Phase-weighted distribution for calculating C2M eye parameters (in support of comment #39)

Adee Ran, Cisco

IEEE 802.3ck Task Force

P802.3ck VEC centering (BoxCar) around t_s

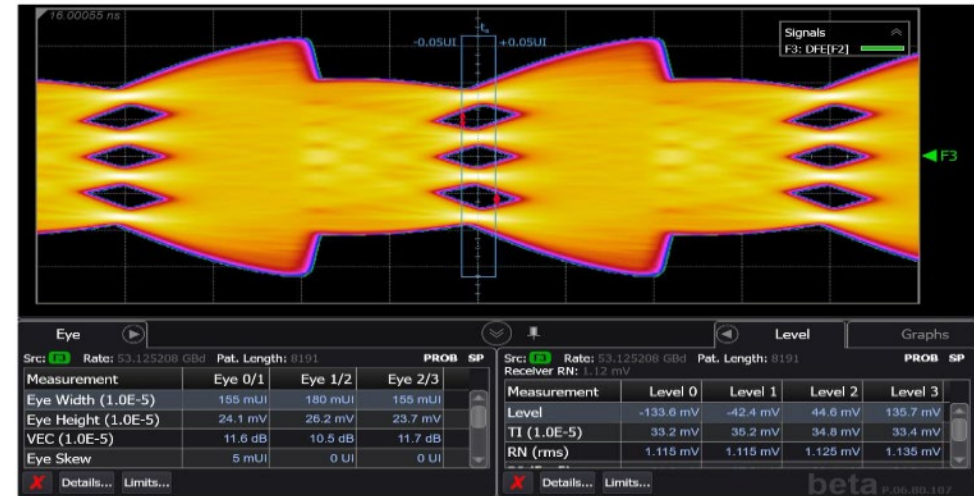
The signal above passes VEC – but high-loss TP1a eye fails

Figure 120E-13—PAM4 eye measurements

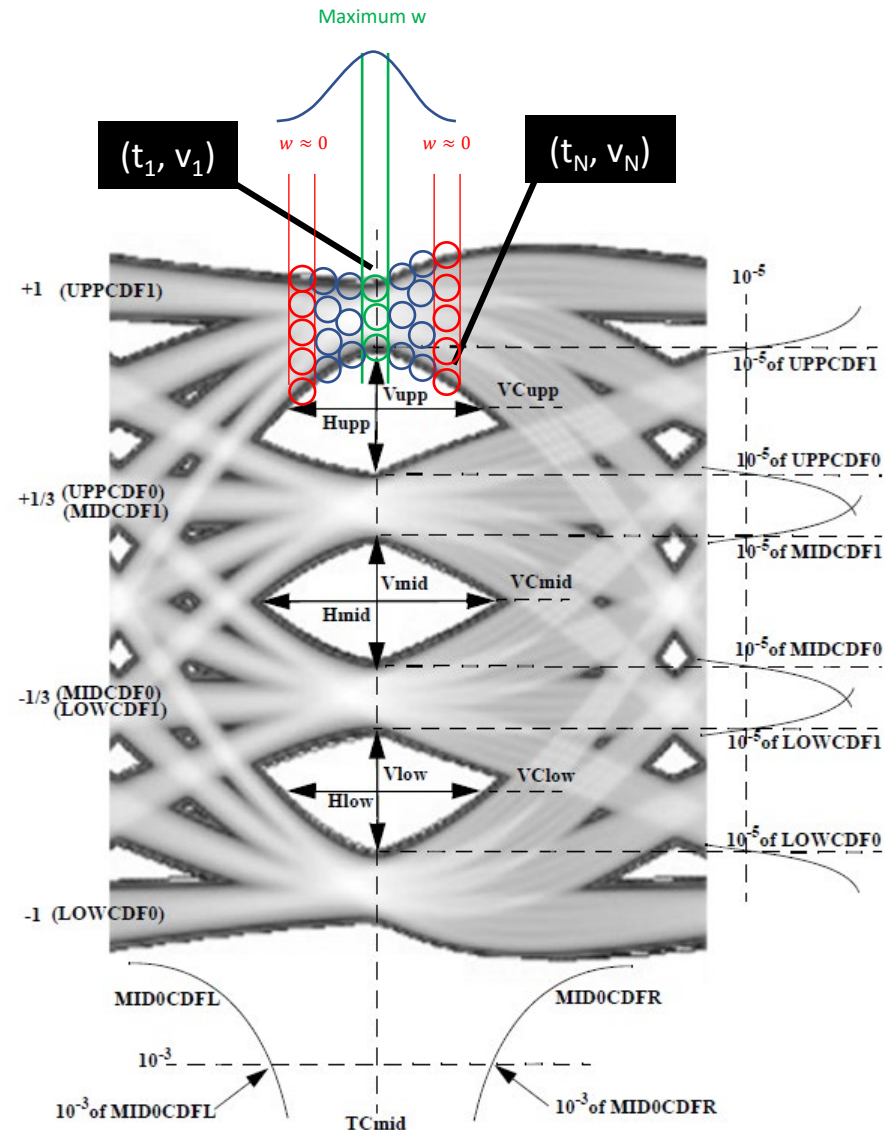
Assume the scope collects a set of samples (t_i, v_i) as illustrated on the right.

The **red** samples should be weighted down compared to the **green** samples.

Results

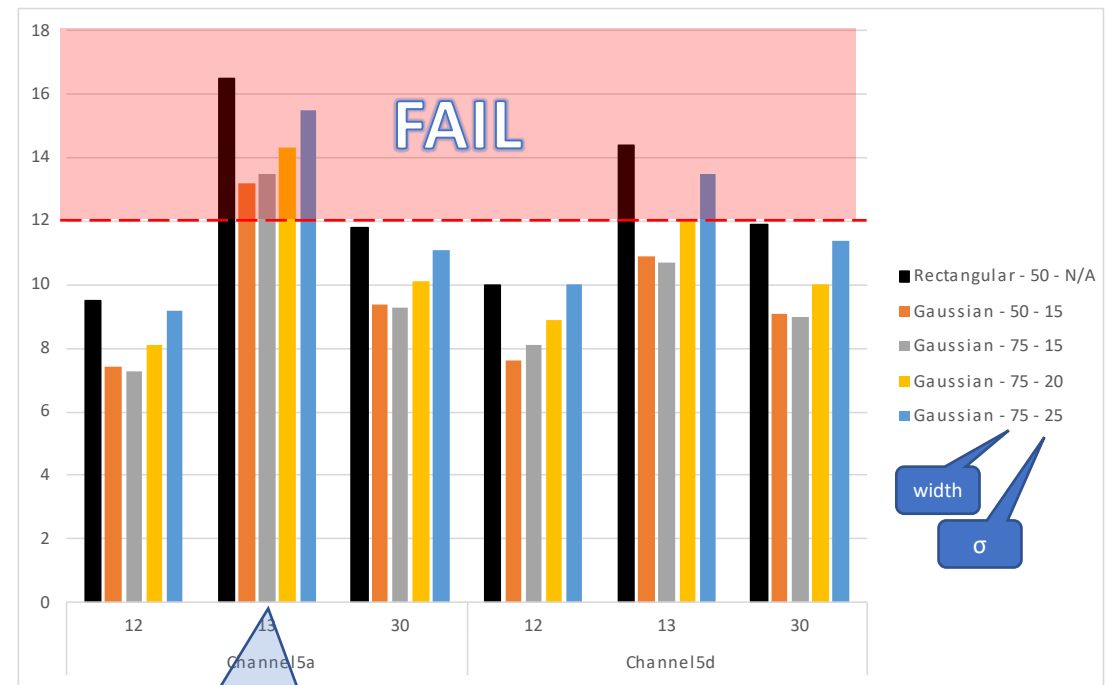
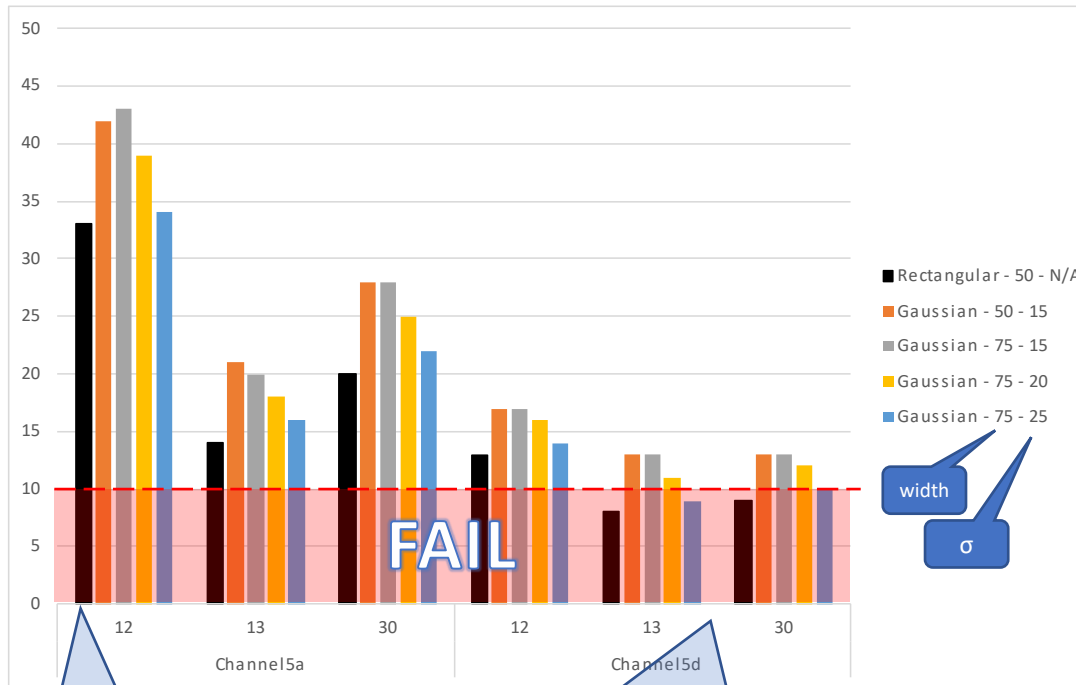
Results in black match slide 6 of ghiasi_01_0721

To make this channel pass with multiple packages we need Gaussian weighting with σ of 15-20 mUI

Window size (truncation of the Gaussian) has minor effect compared to σ

This short channel with bad reflection still fails VEC – as we want
